Subject: Issuance of Amendment No. 72 to Facility Operating License NPF-9 and
Amendment No. 53 to Facility Operating License NPF-17 - McGuire
Nuclear Station, Units 1 and 2 (TACS 61179/61180)

SAFETY EVALUATION BY THE OFFICE OF NUCLEAR REACTOR REGULATION
RELATED TO AMENDMENT NO. 72 TO FACILITY OPERATING LICENSE NPF-9
AND AMENDMENT NO. 53 TO FACILITY OPERATING LICENSE NPF-17

McGUIRE NUCLEAR STATION, UNITS 1 AND 2

FIGURE 5.1-4

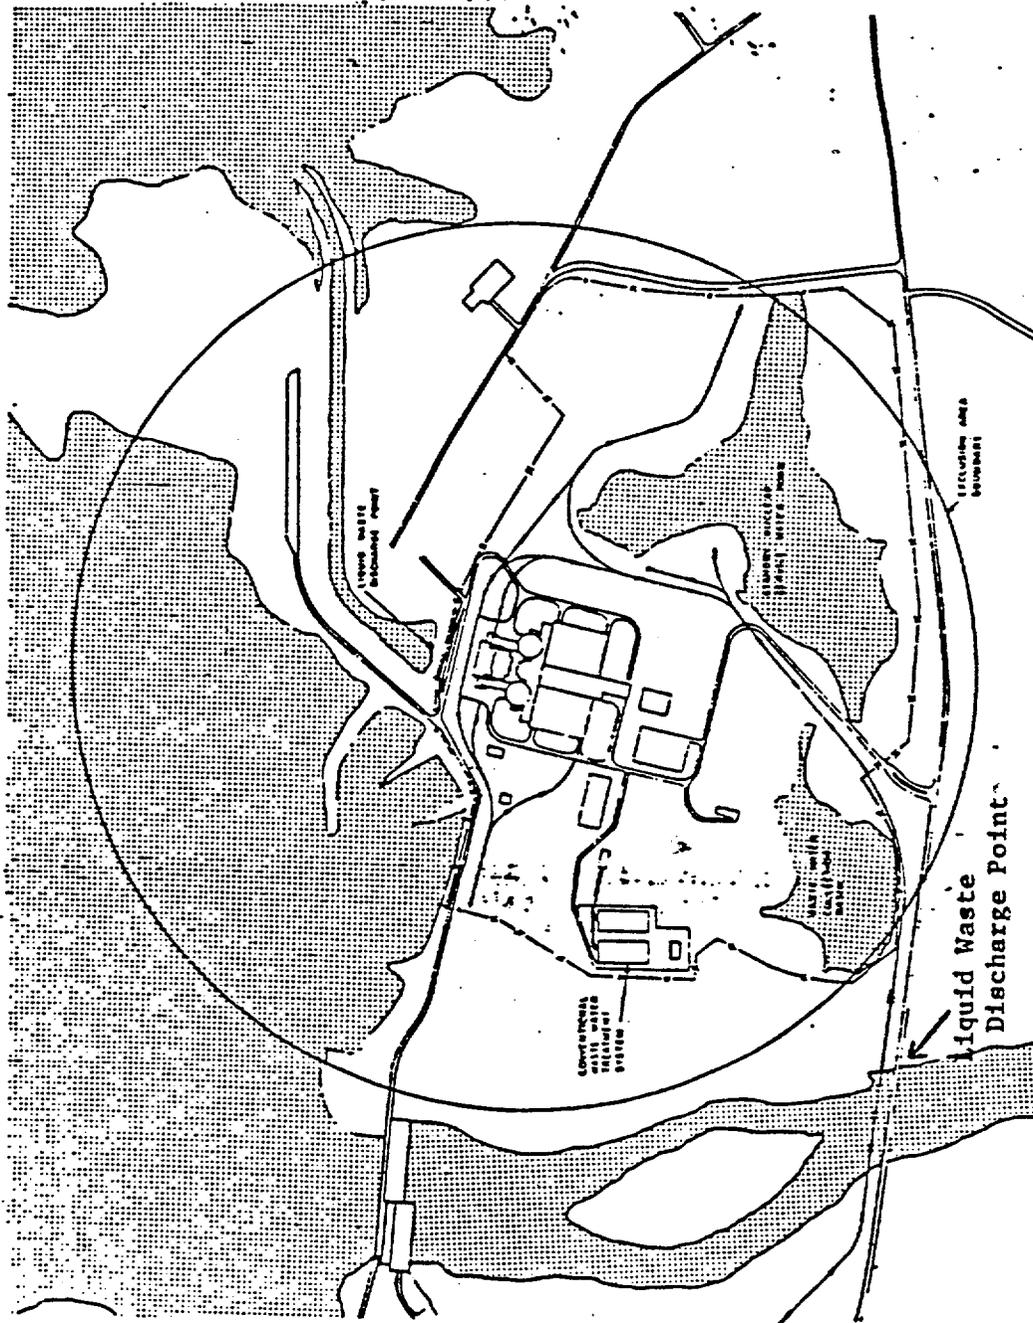
The amendments change Technical Specification Figure 5.1-4 to add another discharge point from the Conventional Wastewater Basin into the Catawba River. The amendments are effective as of their date of issuance.

Existing Technical Specification (TS) 3.11.1.1 and its referenced Figure 5.1-4, "Site Boundary for Liquid Effluents" define the authorized discharge point for radioactive material released in liquid effluents to unrestricted areas as being only to Lake Norman, an upstream impoundment of the Catawba River. By letter dated March 19, 1986, Duke Power Company (the licensee) requested a change to the TSs for McGuire Nuclear Station, Units 1 and 2. This proposed change would modify Figure 5.1-4 to add a new release point for radioactive liquids and thereby permit the release of liquids containing trace quantities of radioactivity into the Catawba River, via the conventional waste water treatment system. The change would affect only the discharge location, and would not increase existing TS limits regarding (1) the quantity of radioactive material contained in the treatment pond, (2) allowable doses to the public from releases to unrestricted areas, and would not decrease existing TS requirements regarding liquid discharge monitoring. The licensee provided additional information to support the request by letters dated December 3, 1986 and June 4, 1987.

The change would be accomplished by deleting from TS Figure 5.1-4 an existing, obsolete footnote which authorized a one-time discharge to the Catawba River on June 20, 1986, but retaining the existing arrow at the river and its label, "Liquid Waste Discharge Point." (The existing arrow, label, and footnote were added in response to a separate application by the licensee submitted subsequent to the March 19, 1986 request.)

The staff concludes that this proposed technical specification change is in accordance with release requirements of 10 CFR Part 50.36a, Part 50 Appendix I and 10 CFR 20 Appendix B; and in accordance with 10 CFR Part 50 Appendix A, General Design Criterion 64 requirements for monitoring radioactivity releases. The change does not increase the liquid effluent release rates or the annual dose resulting from station liquid effluent releases. Thus, although the effluent release path is changed, neither the dose, quantity nor concentration of radioactive effluent in the River is changed. Therefore the proposed change is acceptable.
